Re: Final Work Plans
Delivery Order No. 028
Site 4 Soil Removal
Former Naval Surface Warfare Center – White Oak
Contract No. N62470-97-D-5000

**FINAL
WORK PLAN
FOR
SITE 4 SOIL REMOVAL
FORMER NAVAL SURFACE WARFARE CENTER-WHITE OAK
SILVER SPRING, MARYLAND**

Re: Review of Revised Draft Work Plan for Site 4 Soil Removal for the Former Naval Surface Warfare Center

**SITE 4 WORK PLAN
RESPONSE TO EPA REGION III COMMENTS**

| FIGURE 1 | | | | | |

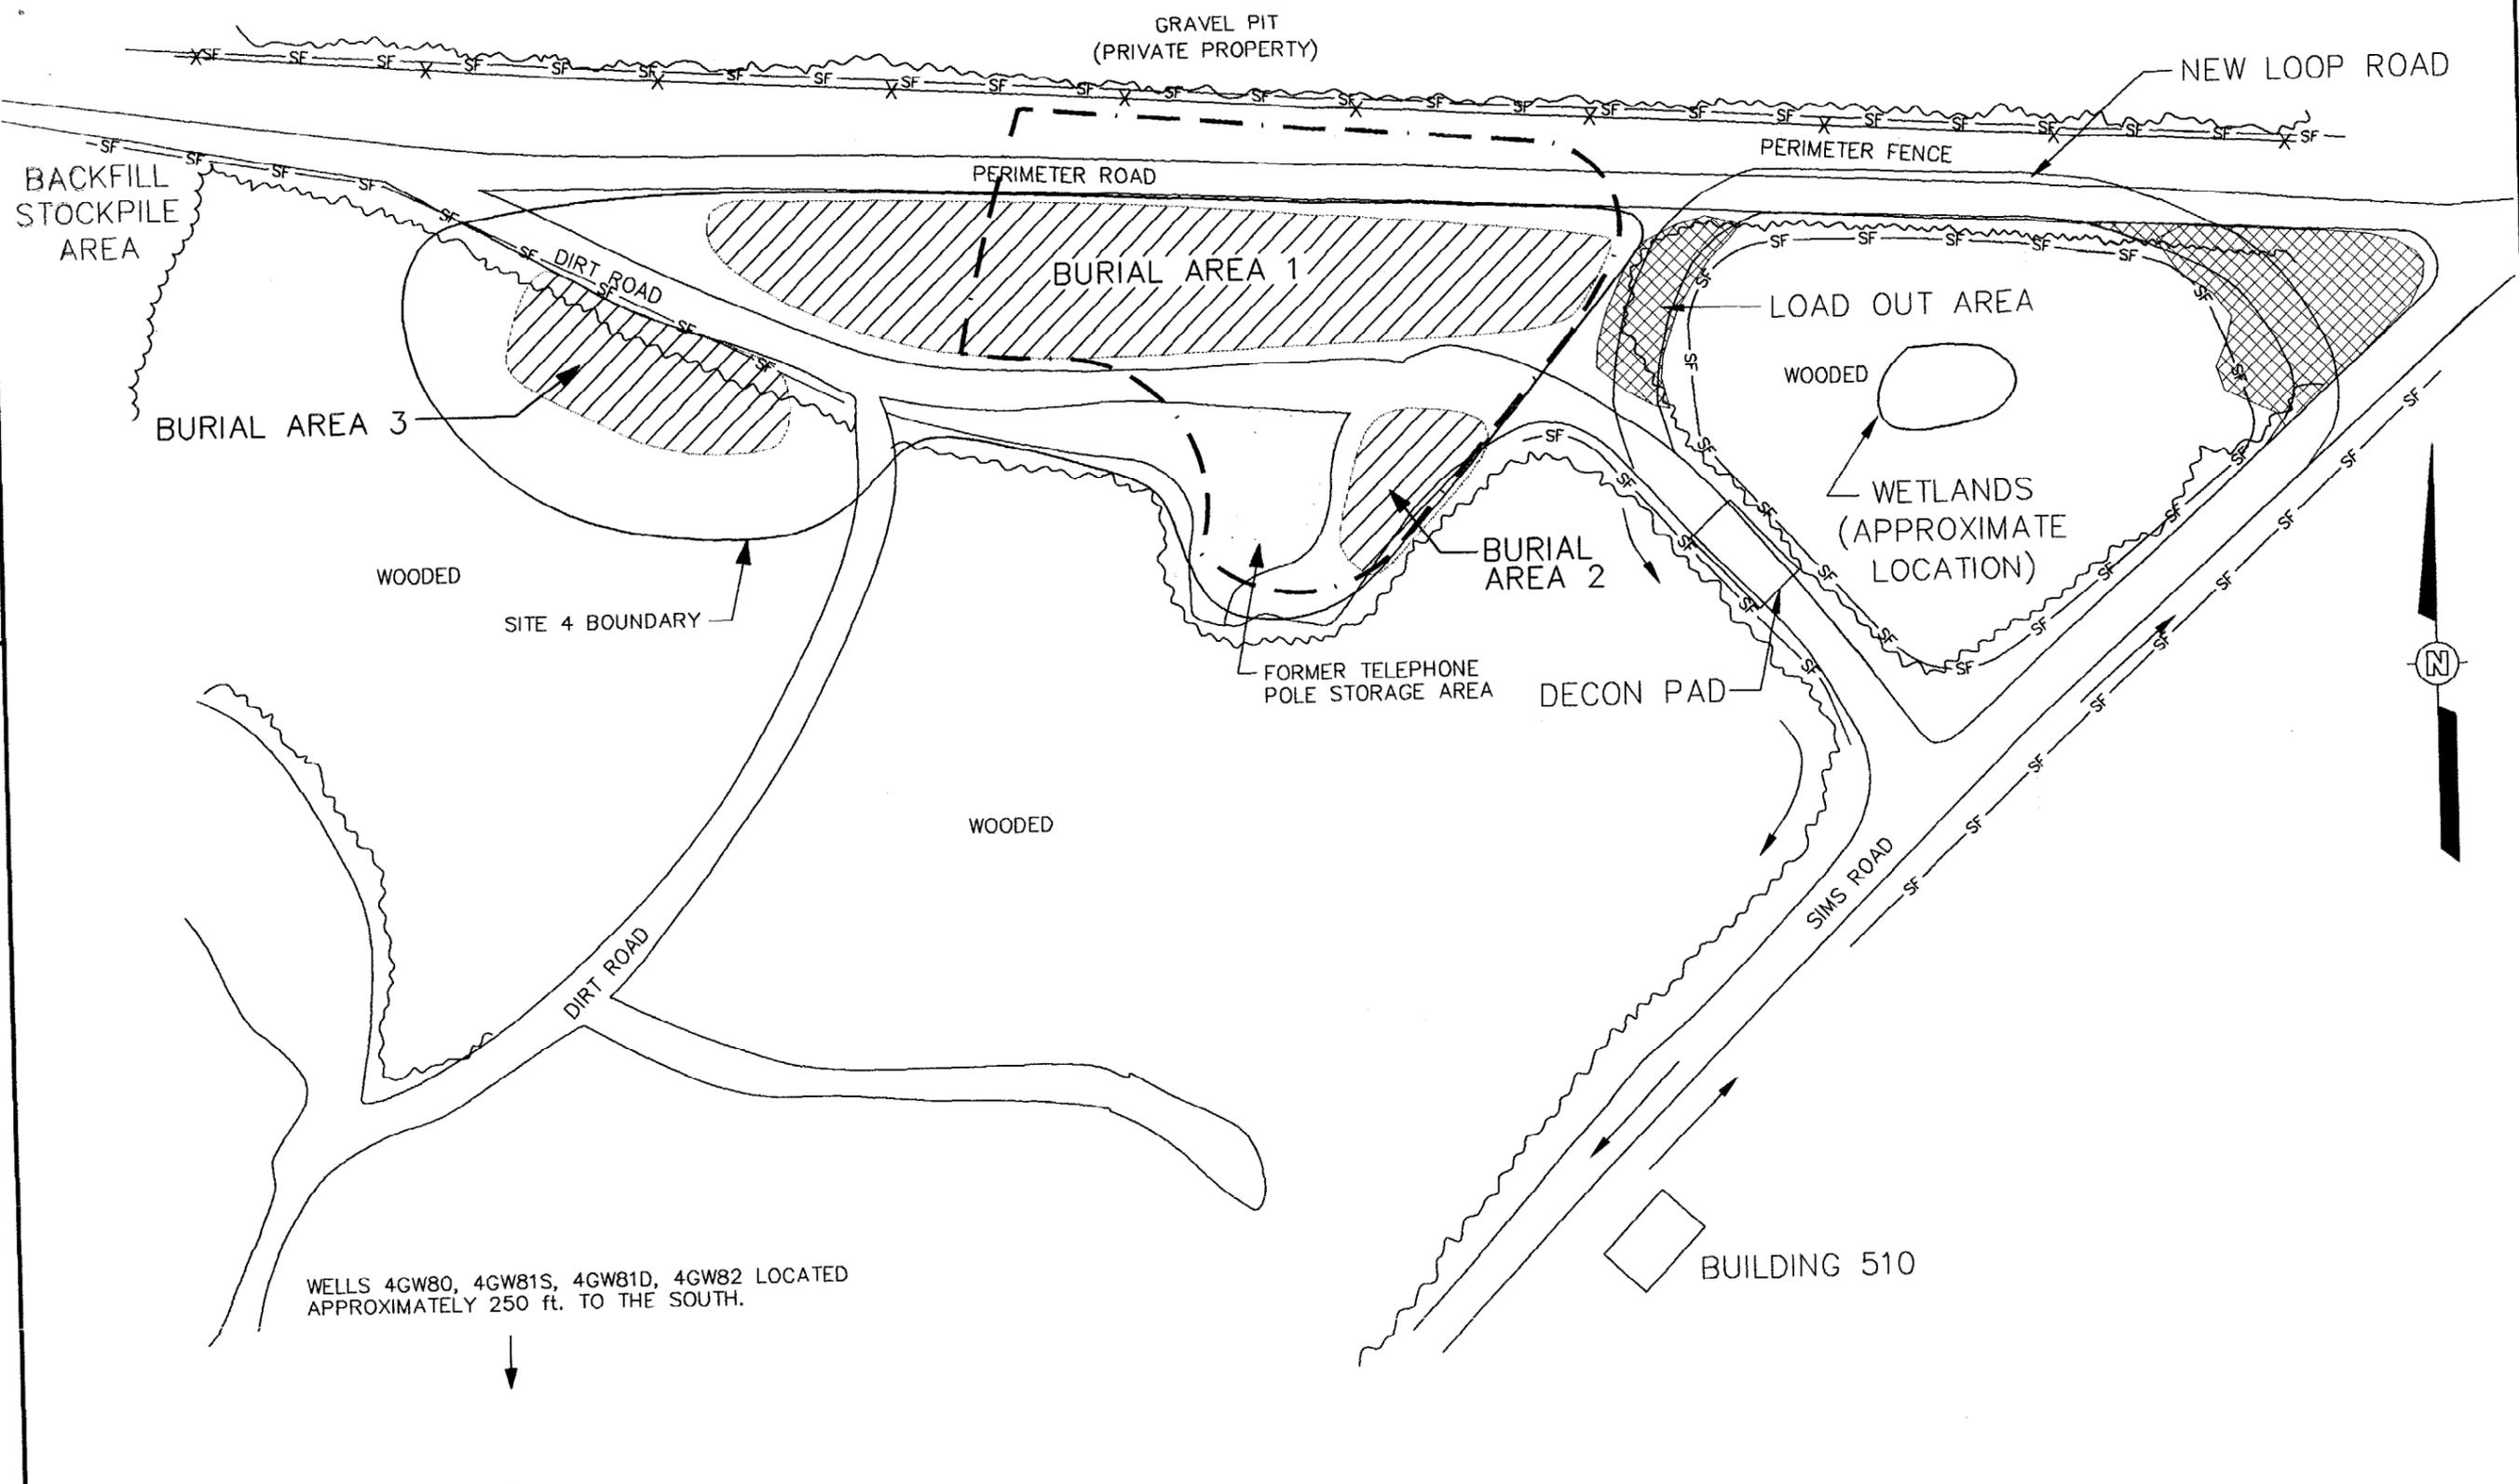
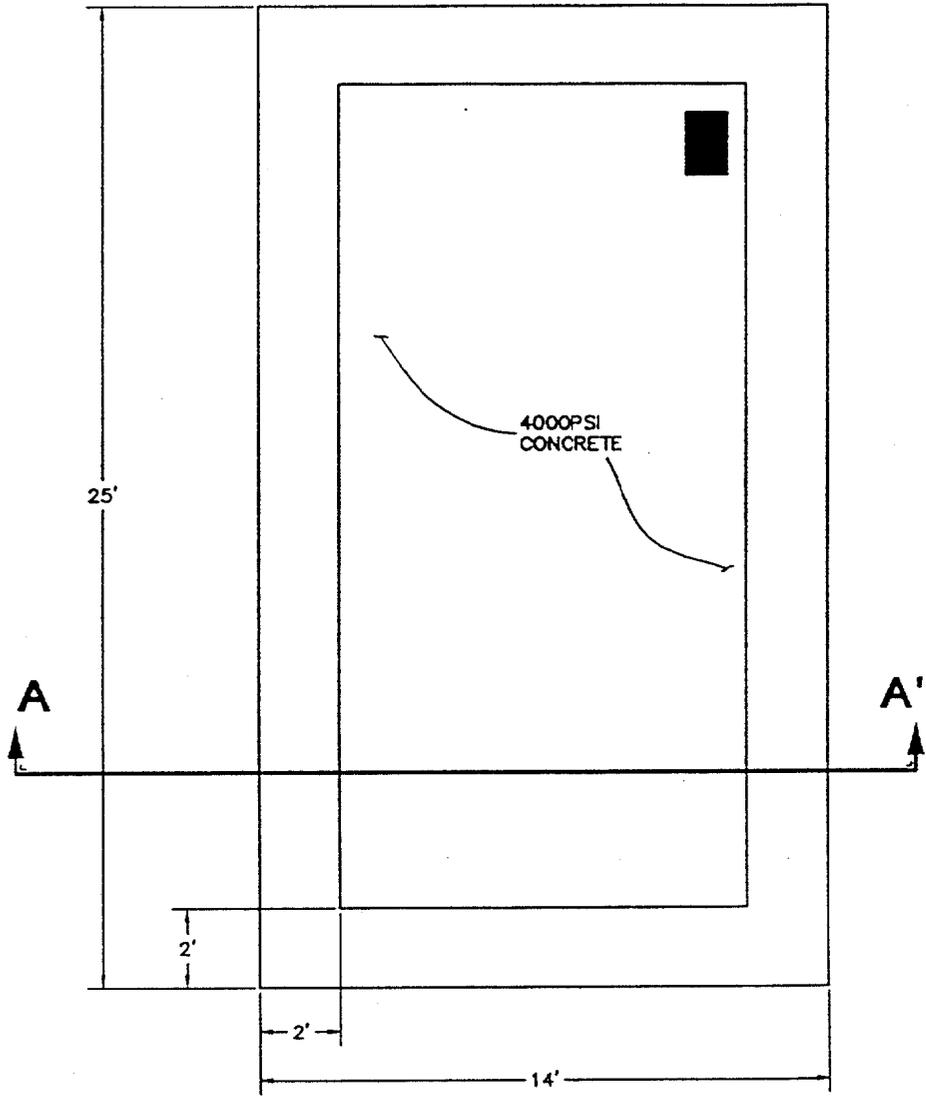
5. The WP states that waste excavated from the burial areas will be placed in the eastern end of Site 4 before loading onto trucks for off-site disposal, is this the Load Out Area as shown in Figure 1? If it is, specify in the narrative. Also, specific information about the Load Out Area (which is a soil staging area) is not provided. The report should provide

detailed information about the Load Out Area, including how long waste will remain in this area, whether waste will be covered, the construction of berms around the area, and whether a liner will be used.

5. The load-out area shown on the drawing will be where disposal trucks are positioned during load-out of excavated soil. The area is outside the contaminated zone. The area itself will consist of a layer of geotextile fabric and six to eight inches of compacted stone. At the completion of the excavation the stone and geotextile will be removed and disposed of off-site.
